RE: Field Issue of over bored studs for Lot #72 Hawthorne Ridge – 1518 Arbor Falls Lee's Summit, MO 64082 – Permit # PRRES20213494

This letter addresses the over bored holes in jack studs for fireplace and window to the left of fireplace.

FIGURE R602.6(1) NOTCHING AND BORED HOLE LIMITATIONS FOR EXTERIOR WALLS AND BEARING WALLS

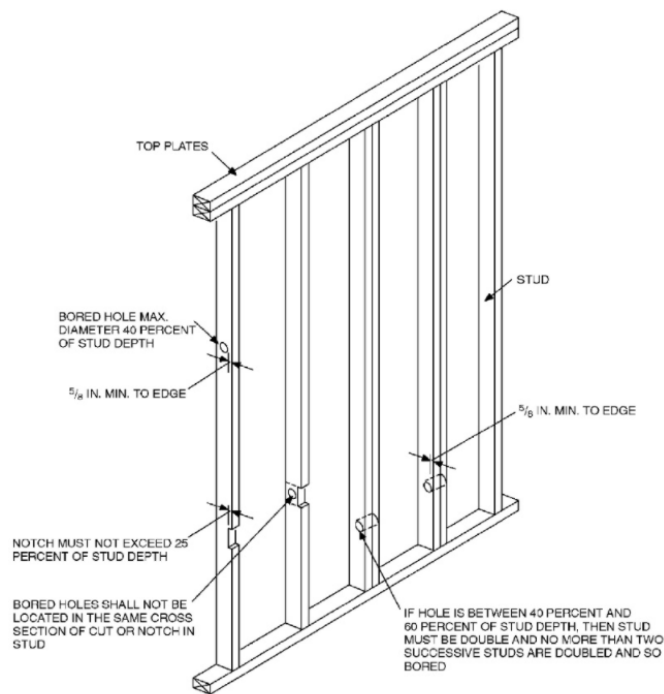
- Distance from edge of hole to edge of stud is .75" – 1".
- Diameter of holes are 1.5" – 2" (approximately 40-60% of stud depth)
- Studs are 2x4 @ 16" oc with approximately 720-900 plf.

- Install Simpson HSS2-2-SDS3 stud shoe on over bored double jack studs from great room window left of fireplace.
- Install Douglas Fir Larch #2 2x4 rotated stud adjacent to (4) 2x4 stud pack left of fireplace.
